ATHENS PLANNING COMMISSION

Case #23-02: University Estates P.U.D./Homestead Court & Broadmoor
Affordable Housing Development

**City of Athens Engineering and Public Works
Private Development Plan Review Response Summary**

Property Name: University Estates, Broadmoor Court Extension, Homestead Court Extension

DATE	
07/31/2023	
SCALE	
DRWN. CDK	CHCK. CDK
JOB NO. 201656	
SHEET NO.	
SV-2

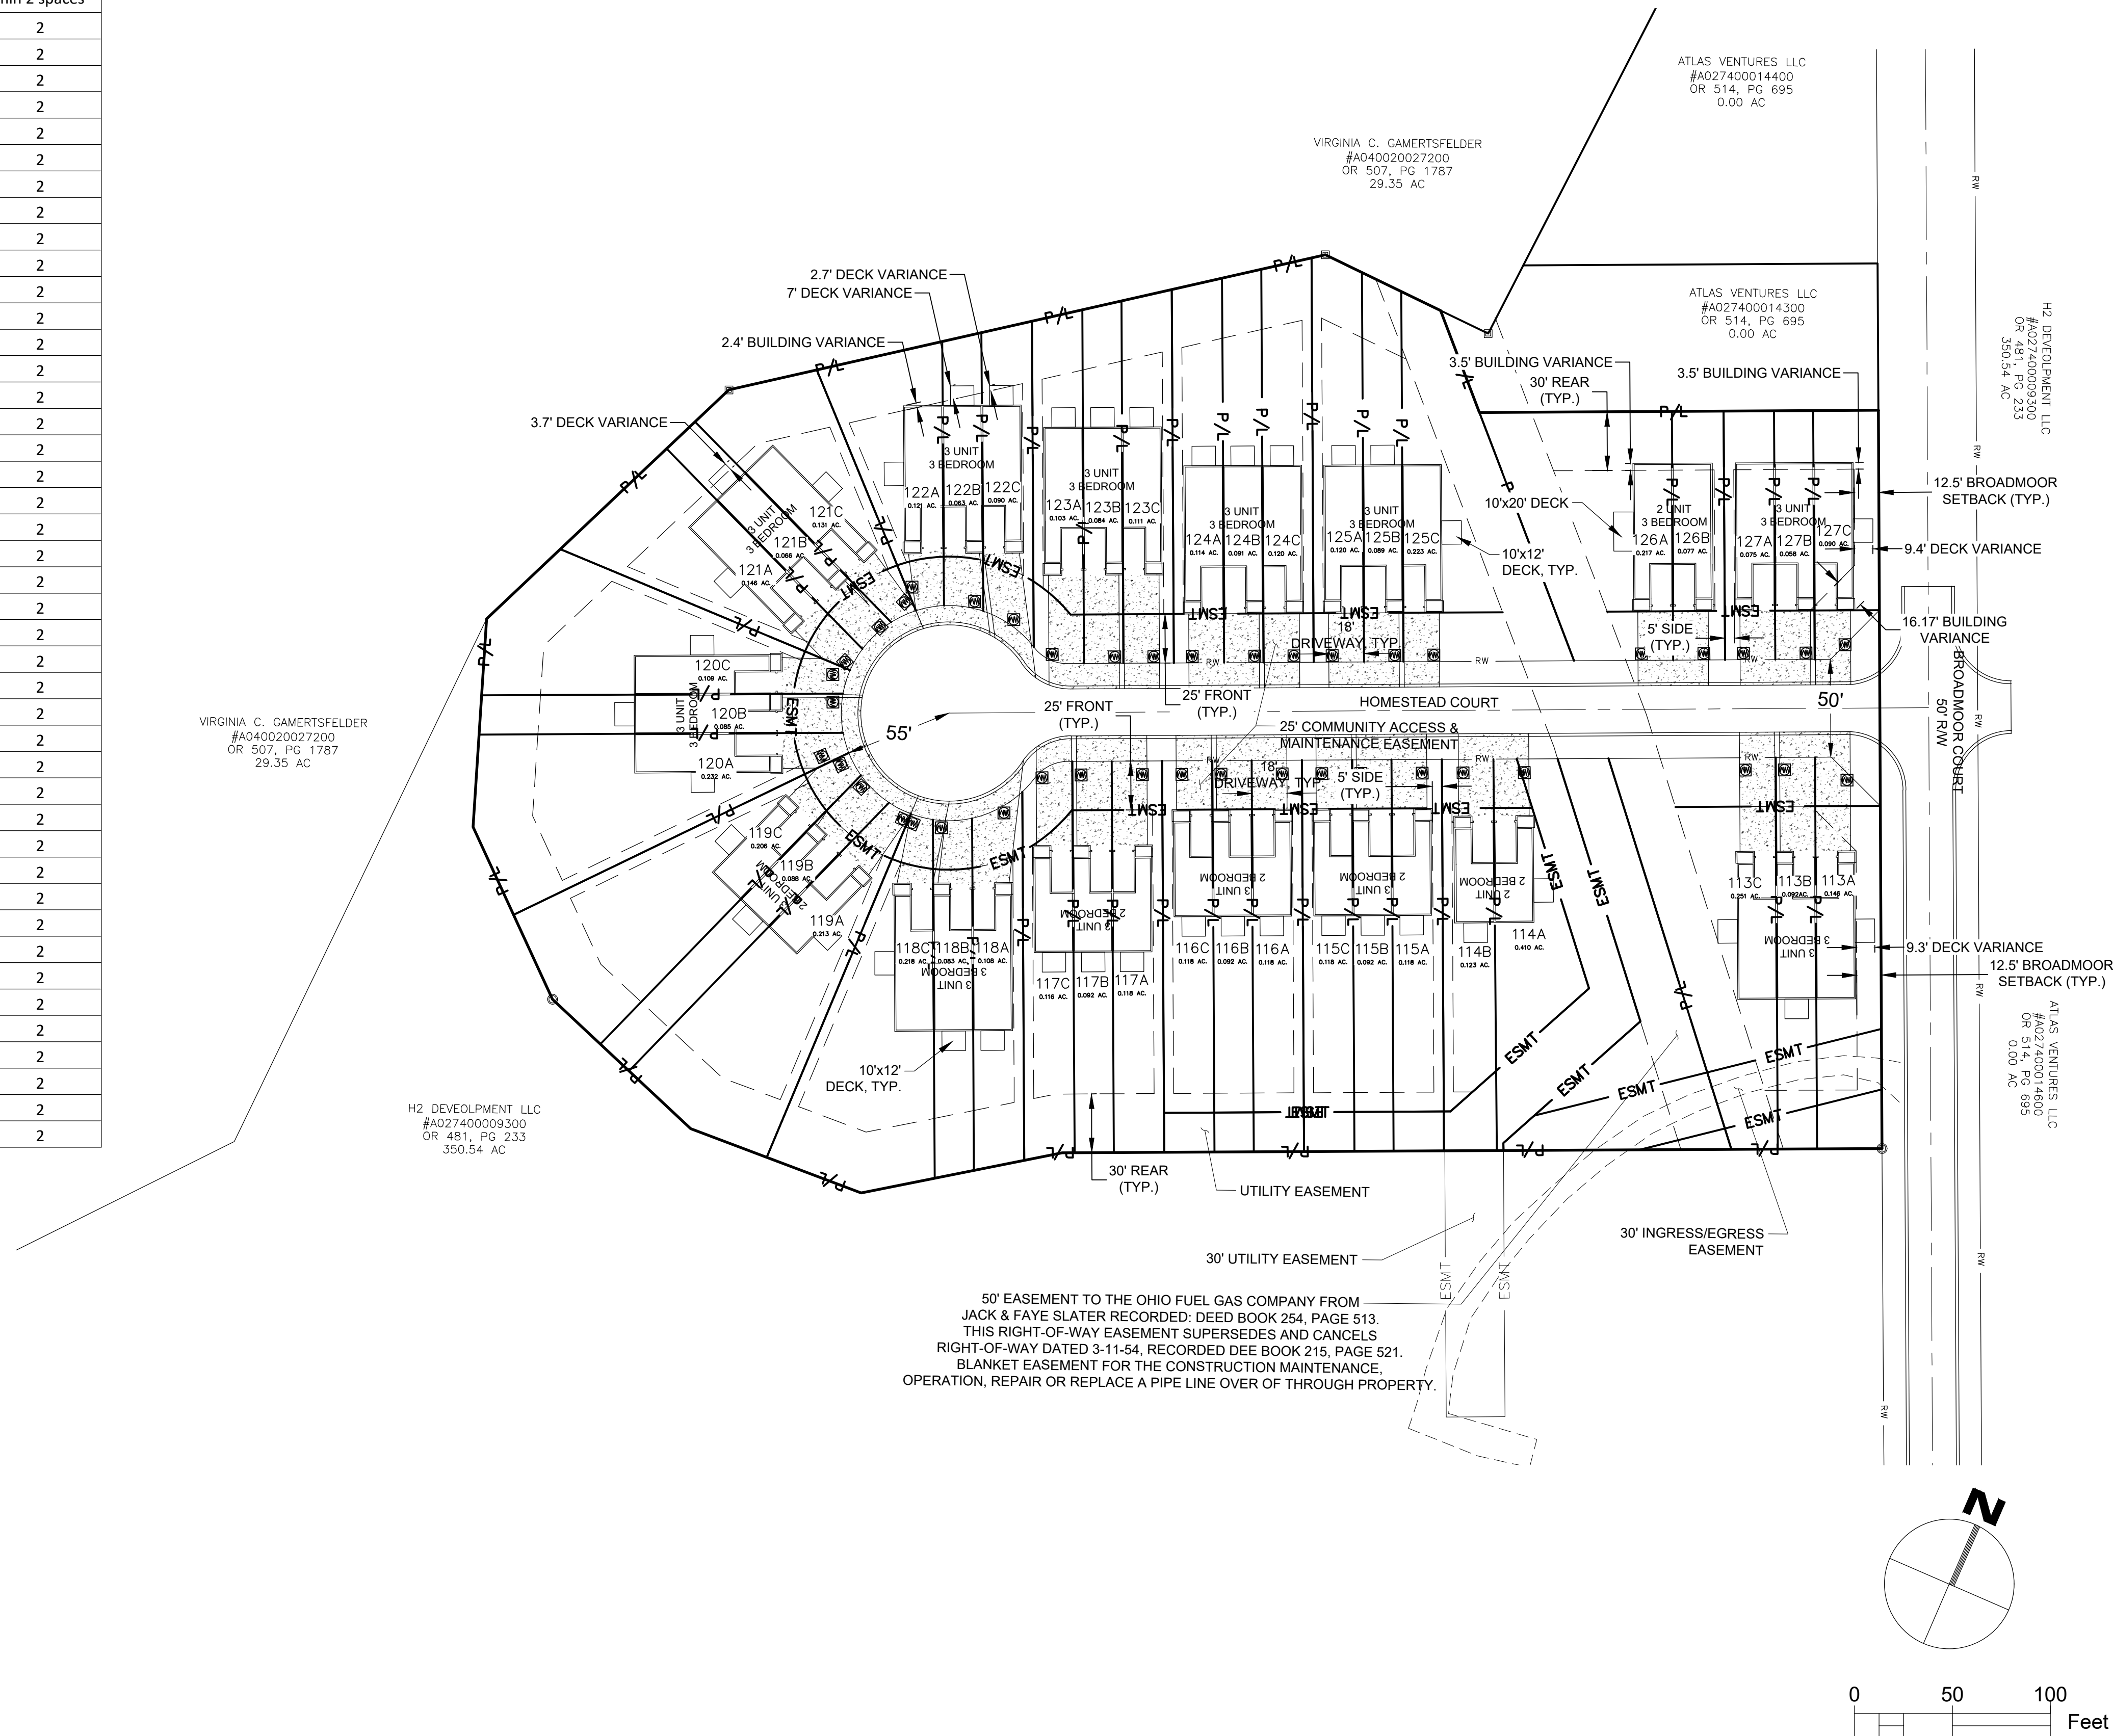
- 163 ACC 23.10 Table "A" bulk control non-conformities for lot size, lot width, setbacks and impervious lot coverage as detailed in the table of sheet SV-2
- 6 ACC 23.10 Table "A" bulk control total lot coverage non-conformities
- 6 ACC 23.03.11(B) deck setback non-conformities
- A non-conformity from ACC 21.09.05 and 21.09.06 requiring common open space of at least 20%
- A non-conformity from ACC 21.07.05 requiring a street tree plan
- A non-conformity from ACC 27.02.04 requiring storm water retention

INTERNAL SANITARY BOWL DROP CONNECTION DETAIL
NO SCALE

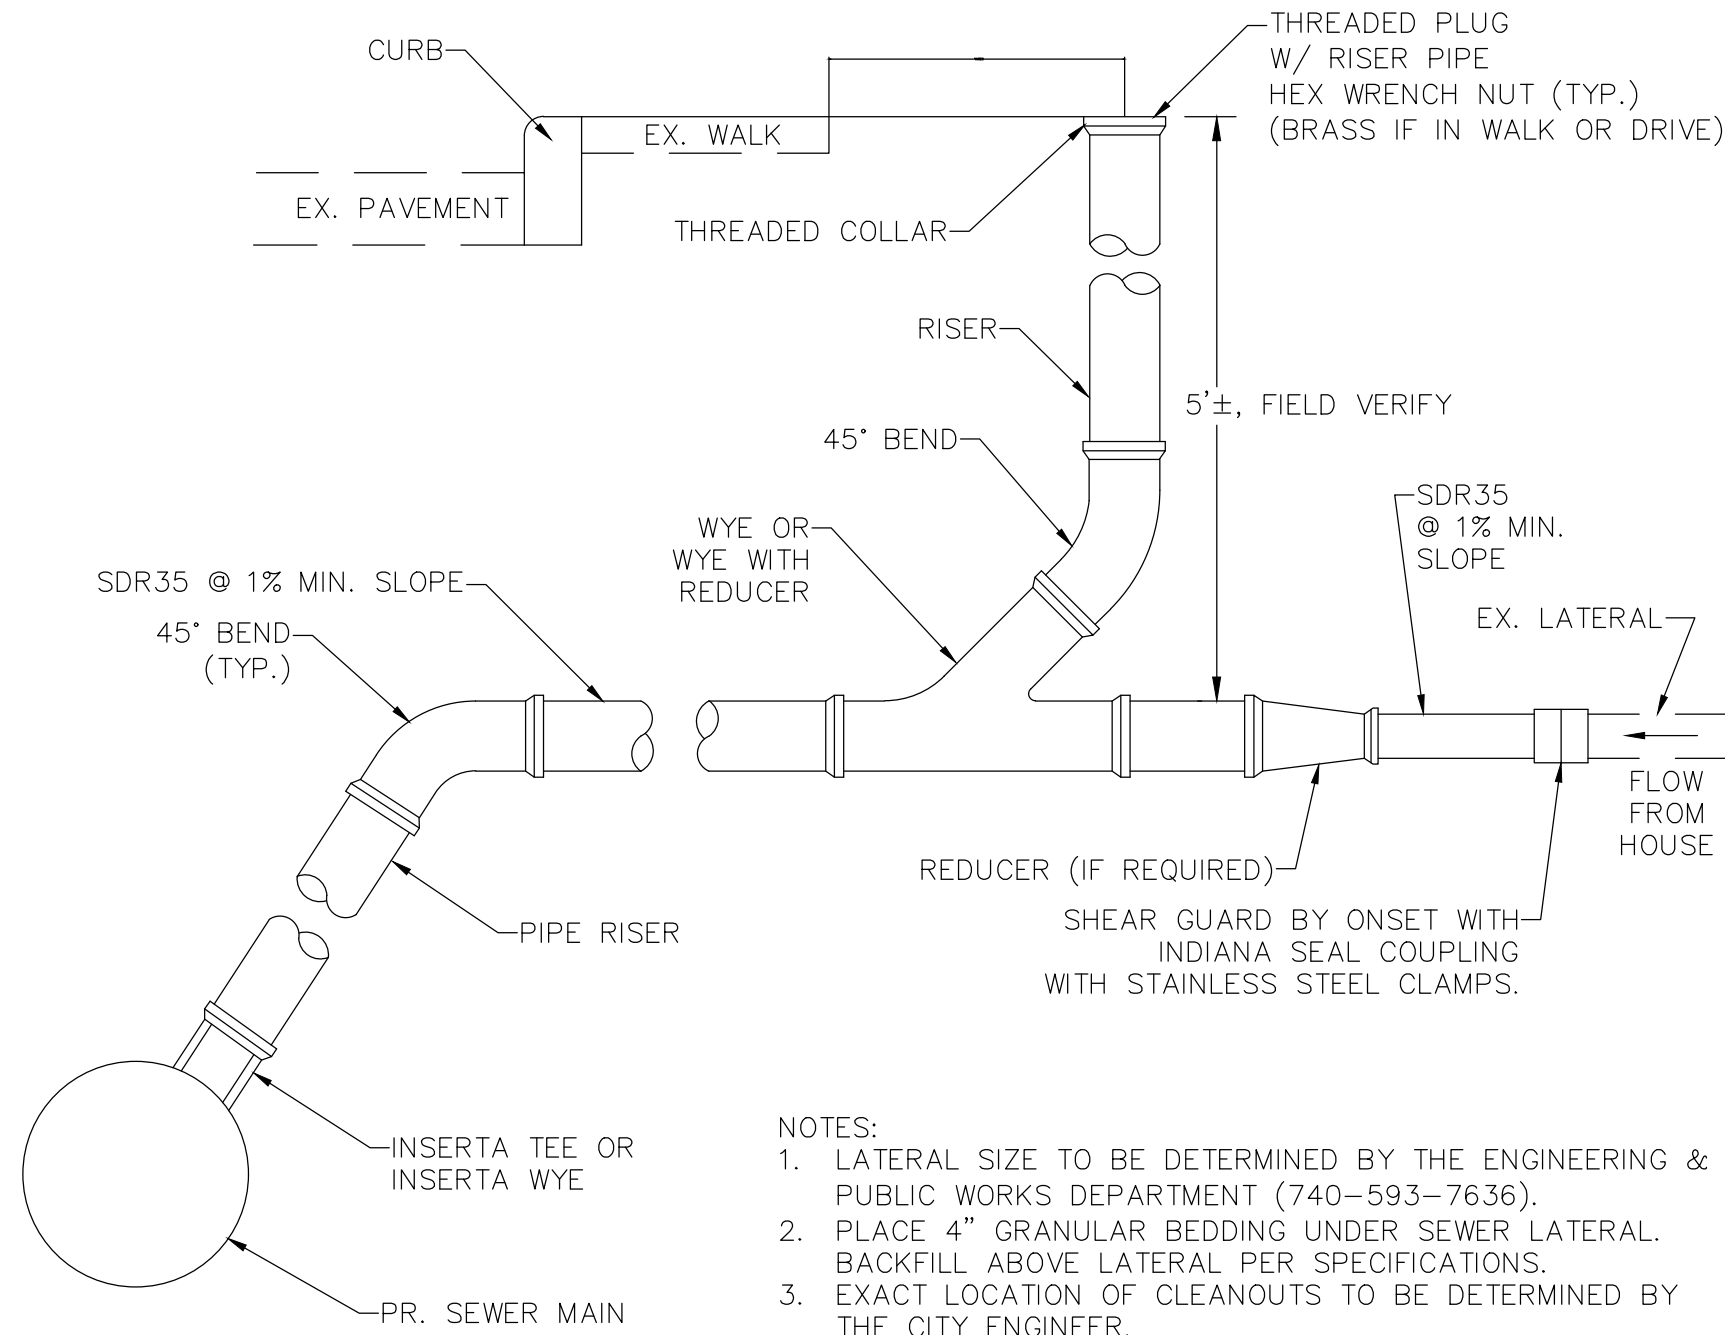
1. Please review depth of the proposed sewer to determine if it can be shallower.
Sanitary sewer shallowed where possible, see revised plan and profile.
2. Please change the external drop manhole detail to an internal bowl drop manhole.
Detail changed.
3. Provide copies of the OEPA Permit to Install Approval for city records.
Will provide upon OEPA approval.
4. The contractor/developer should provide 48 hours of advance notice to the City Engineering and Public Works Department to witness installation and testing of the sewer line.
Note Added to Sanitary General Notes sheet and sanitary sewer plan and profile sheet.

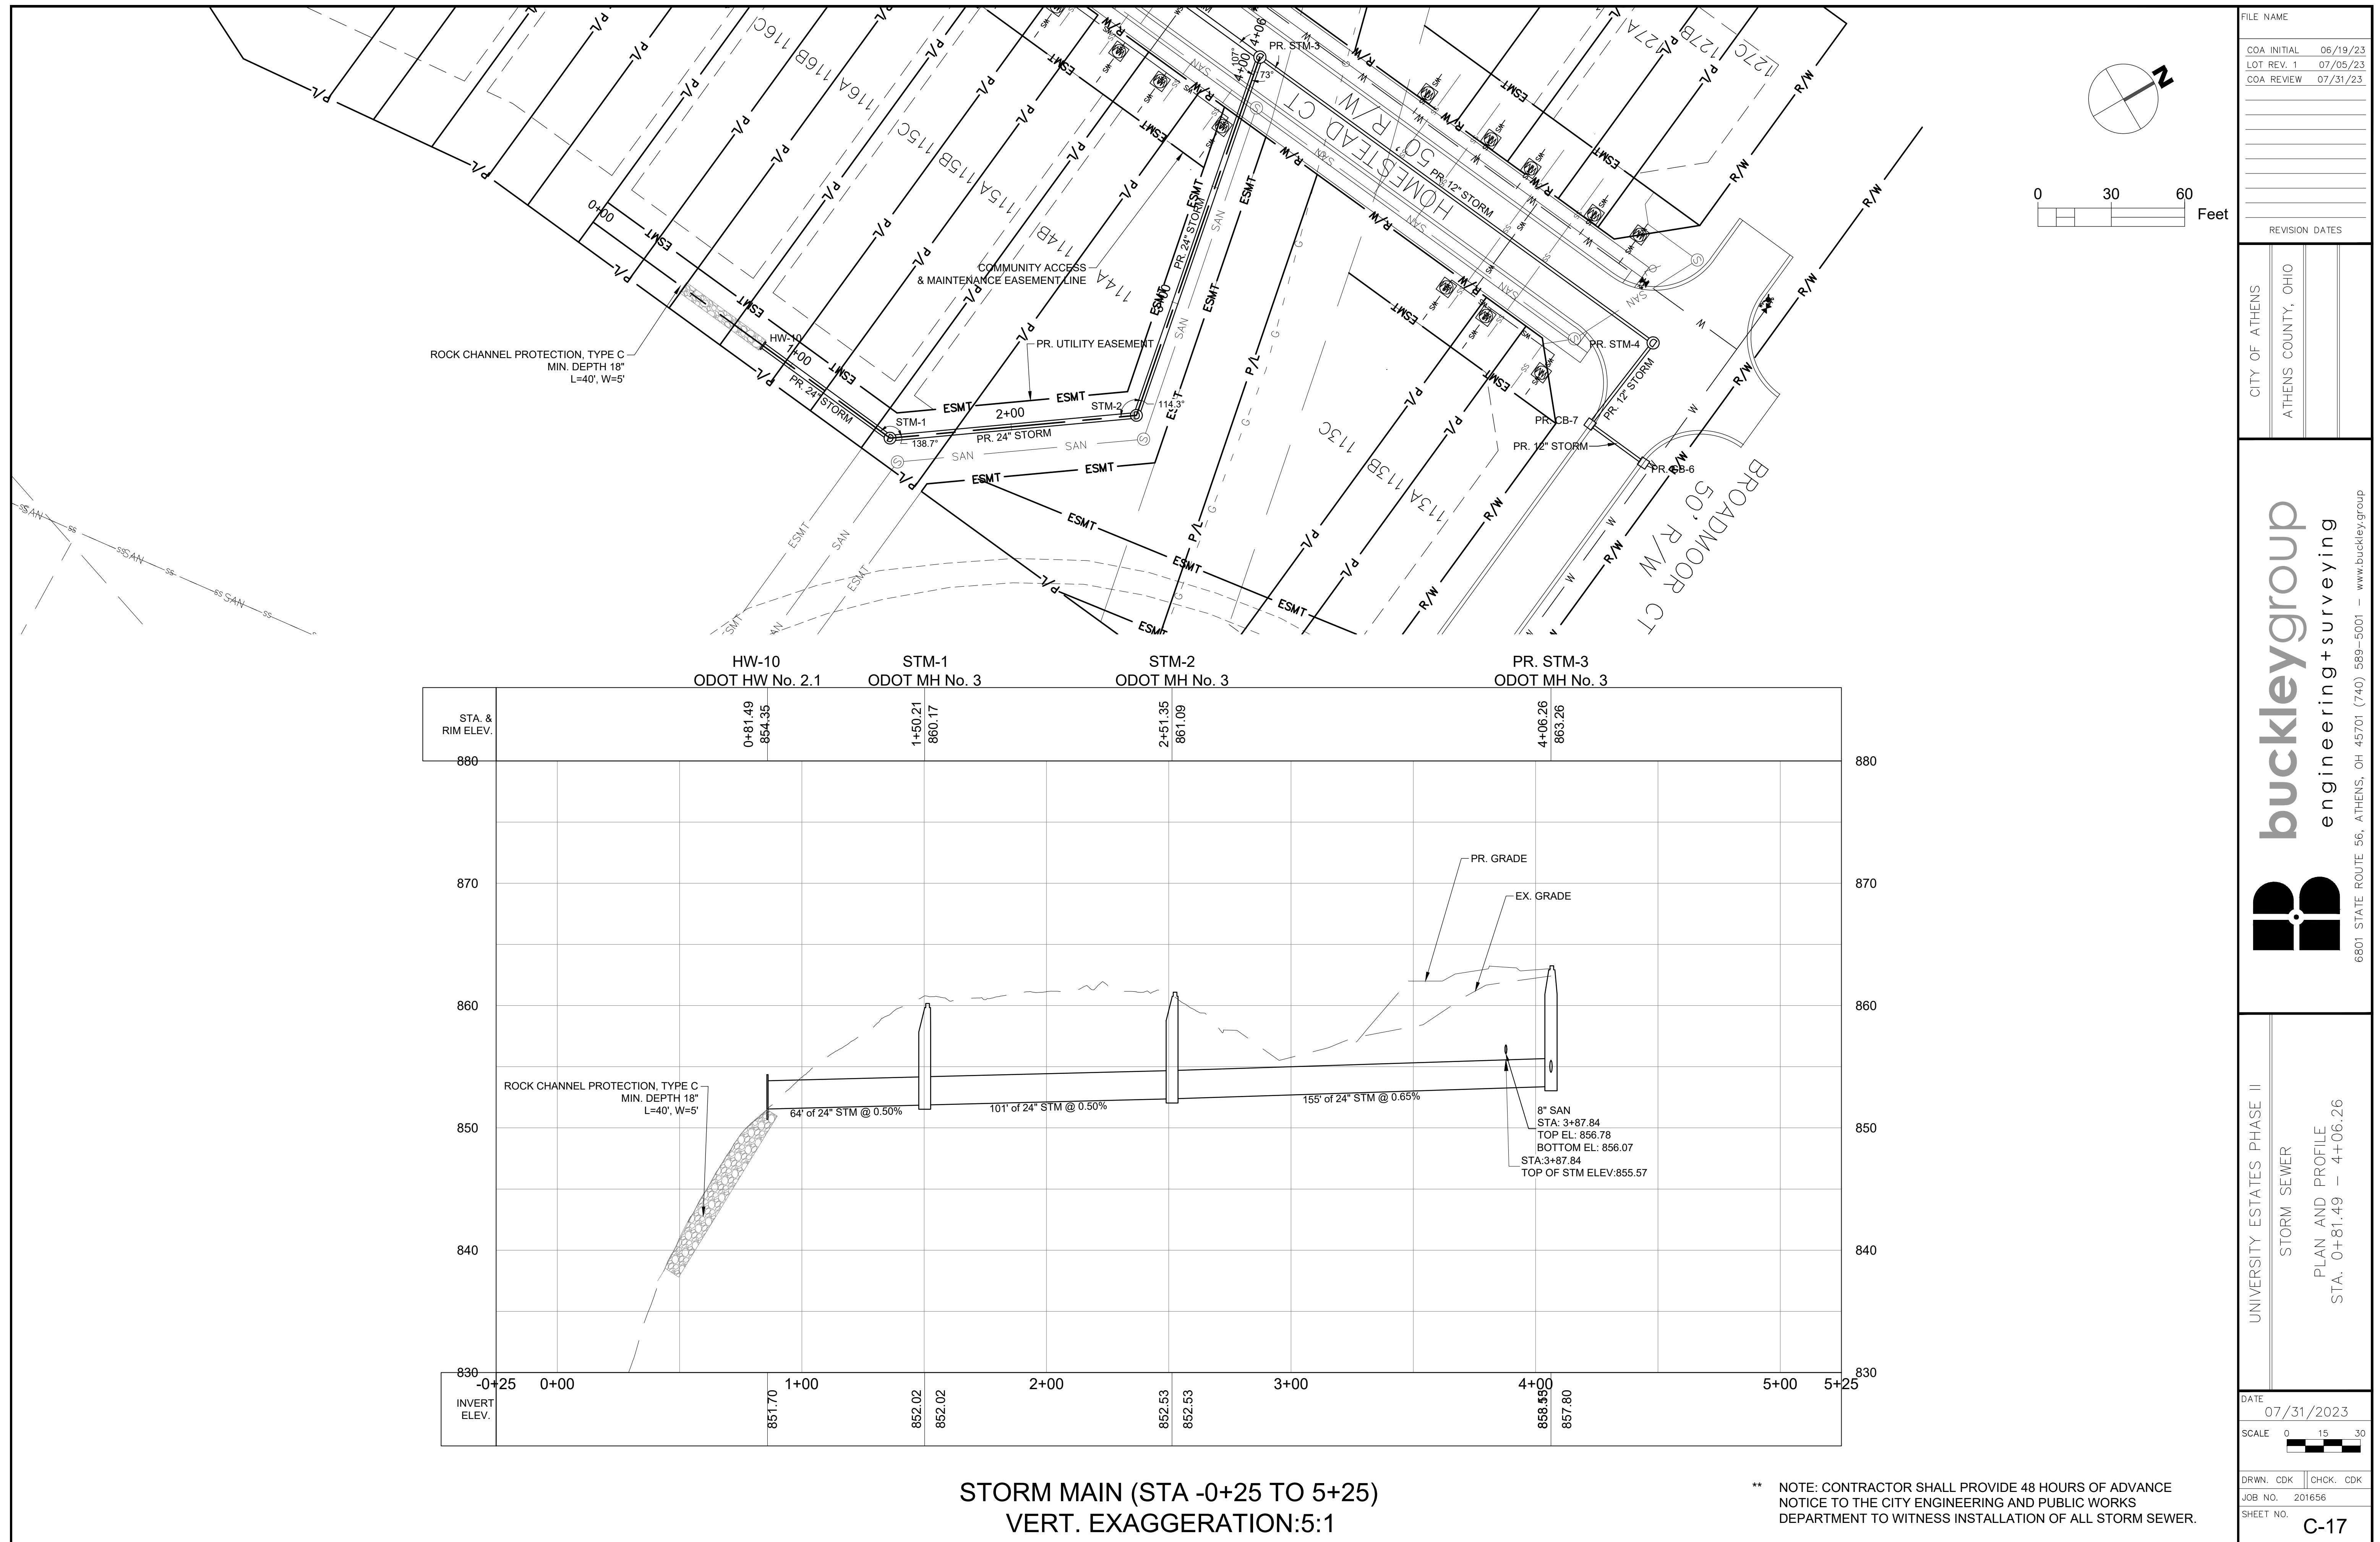
1. Please review the storm outfall on Sheet C-13. There appears to be a steep grade below the storm outlet.
Vertical Exaggeration is 5:1 on the profile. Discharge point is on the opposite side of the ravine of the Homestead Ct development. This is the only place to discharge within the boundaries of the owner's property and maintain space for construction of the density of structures required for this project.
